Re: Turkey Point Units 3 and 4  
Docket Nos. 50-250 and 50-251  
Response to NRC Request for Additional Information Regarding  
Extended Power Uprate License Amendment Request No. 205 and  
Containment and Ventilation Issues

RESPONSE TO NRC RAI REGARDING EPU LAR NO. 205  
AND SCVB CONTAINMENT AND VENTILATION ISSUES

**Figure 1: Calculated Minimum Containment Pressure for CLB and EPU BELOCA Analyses.**

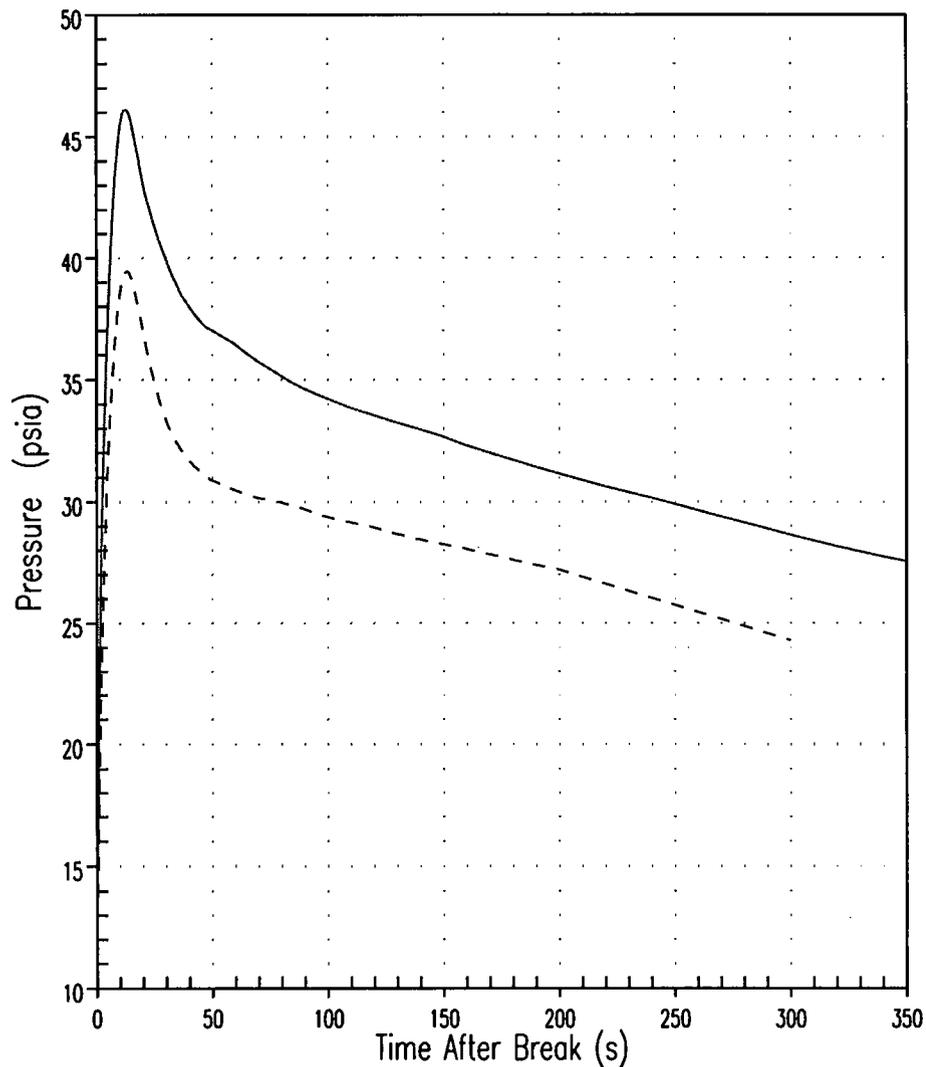
**SCVB-1.11 Section 2.6.6, "Pressure Analysis for ECCS Performance Capability." Provide the minimum containment pressures calculated during reflood for the current licensing basis and for the proposed EPU.**

The minimum containment pressures calculated by the COCO computer code through the entirety of the transient are included in Figure 1 for both the current licensing basis and the EPU BELOCA analyses.
